# Access Compliance Report

## Public Rights-of-Way

### (Curb Ramps)

Intersection ID: 13870	Main Street: LAMAR_AV	Cross Street: PARK_DR	Location: S
ADA ID: B90216C89DA3	Ramp Type: PerpDiag	Initial Pass/Fail: Fail	Overall Compliance: No
Severity Score: 26.25			
Codes/Mitigation Info/Possible Solution		Field Measurements/Component Compliance

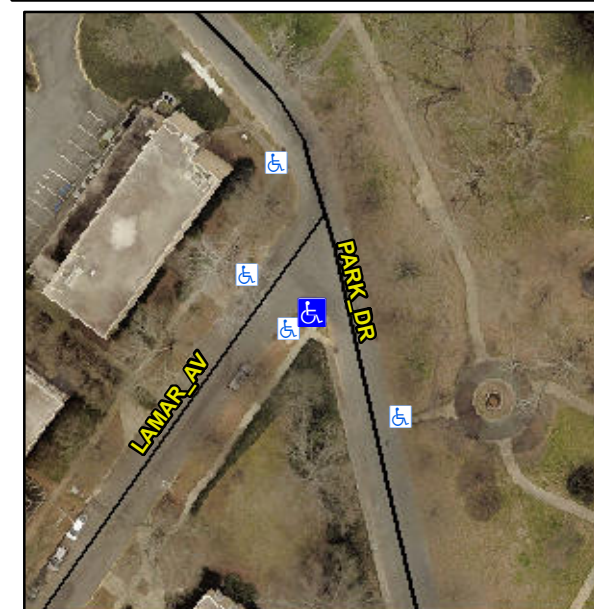
**R304.2.2, R304.5.3**

Compliance	Description	Data	Compliance	Description	Data
N/A	Ramp Length (in)	88.0	No	Ramp Slope (%)	14.5
Yes	Ramp Width (in)	62.0	No	Ramp XSlope (%)	3.9
N/A	Flare Type LT	N/A	N/A	Flare Type RT	N/A
N/A	Flare Slope LT (%)	N/A	N/A	Flare Slope RT (%)	N/A
N/A	Flare Traversable LT?	N/A	N/A	Flare Traversable RT?	N/A
N/A	Landing Length (in)	N/A	N/A	DWS Provided?	N/A
N/A	Landing Width (in)	N/A	N/A	DWS Contrast?	N/A
N/A	Landing Slope (%)	N/A	N/A	DWS Length (in)	N/A
N/A	Landing X Slope (%)	N/A	N/A	DWS Full Width?	N/A
N/A	Landing Curb? (Y/N)	N/A	N/A	DWS Offset (in)	N/A
N/A	Shared Landing?	N/A			
N/A	Gutter Ponding?	N/A	N/A	Gutter Slope (%)	N/A
N/A	Gutter Lip Ht (in)	N/A	N/A	Gutter X Slope (%)	N/A
N/A	Painted X Walk1?	No	N/A	Painted X Walk2?	No
	X Walk 1 Direction	To E		X Walk 2 Direction	To N
N/A	X Walk 1 Width (in)	N/A	N/A	X Walk 2 Width (in)	N/A
	X Walk 1 Slope (%)	1.9		X Walk 2 Slope (%)	2.0
	X Walk 1 X Slope (%)	3.3		X Walk 2 X Slope (%)	2.7

**Remove & Replace Curb Ramp With Two New Directional Ramps or Equivalent.**
